**Subject:** Edwards truss

**Randy, here are the papers on the truss repair for Edwards job. (Permit # 24733)  
Thank you for your help with this matter, Jim**

**Engineering Tracking Form**

**Repair**

2 09/20/06 A4-FXTP

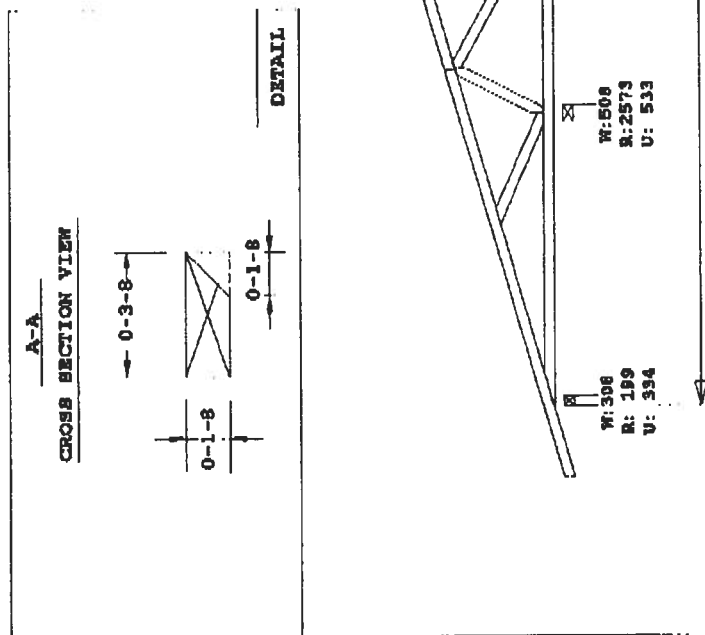
**REPAIR PROBLEM:**

1. Cosmetic filler trimmed 1-1/2" off at 45 degree angle as shown. Do not cut into pitched bottom chord of truss.

After further analysis no repair required.
